Access Compliance Report

Public Rights-of-Way

(Curb Ramps)

Intersection ID: 12524	Main Street: W_1ST_ST	Cross Street: S_CHURCH_ST	Location: W
ADA ID: 1E138508FB54	Ramp Type: BlendTrans1	Initial Pass/Fail: Fail	Overall Compliance: No
Severity Score: 25			
Codes/Mitigation Info/Possible Solution		Field Measurements/Component Compliance

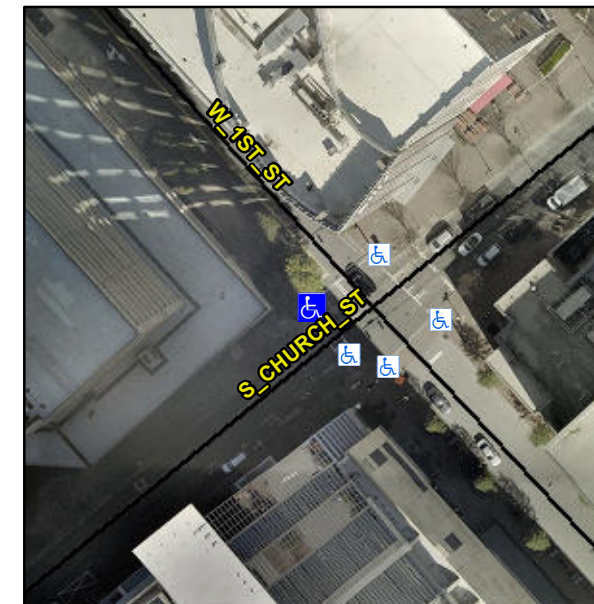
Not Found, R304.5.3

Compliance	Description	Data	Compliance	Description	Data
N/A	Ramp Length (in)	66.0	Yes	BlendTrans Slope (%)	3.2
Yes	Ramp Width (in)	48.0	No	BlendTrans XSlope (%)	9.0
N/A	Flare Type LT	N/A	N/A	Flare Type RT	N/A
N/A	Flare Slope LT (%)	N/A	N/A	Flare Slope RT (%)	N/A
N/A	Flare Traversable LT?	N/A	N/A	Flare Traversable RT?	N/A
N/A	Landing Length (in)	N/A	N/A	DWS Provided?	N/A
N/A	Landing Width (in)	N/A	N/A	DWS Contrast?	N/A
N/A	Landing Slope (%)	N/A	N/A	DWS Length (in)	N/A
N/A	Landing X Slope (%)	N/A	N/A	DWS Full Width?	N/A
N/A	Landing Curb? (Y/N)	N/A	N/A	DWS Offset (in)	N/A
N/A	Shared Landing?	N/A			
N/A	Gutter Ponding?	N/A	N/A	Gutter Slope (%)	N/A
N/A	Gutter Lip Ht (in)	N/A	N/A	Gutter X Slope (%)	N/A
N/A	Painted X Walk1?	Yes	N/A	Painted X Walk2?	Yes
	X Walk 1 Direction	To SE		X Walk 2 Direction	To NE
	X Walk 1 Width (in)	86.0		X Walk 2 Width (in)	113.0
	X Walk 1 Slope (%)	1.5		X Walk 2 Slope (%)	0.5
	X Walk 1 X Slope (%)	1.0		X Walk 2 X Slope (%)	4.4

N/A	Ramp inside XWalk1?	Yes	N/A	Ramp inside XWalk2?	Yes
	Road Slope (%)	5.3		Clear Space?	N/A
	Road X Slope (%)	0.8	N/A	Clear Space to XWalk (in)	N/A
N/A	Any Obstructions?	N/A	N/A	Storm Grate/Utility Hazard?	N/A
	Obstruction Type			Storm Grate/Utility Type	
		N/A			N/A
		Yes		Surface Condition? (G/P)	Good
		No		Curb Slope (%)	9.2

Remove & Replace Curb Ramp With Two New Directional Ramps or Equivalent.
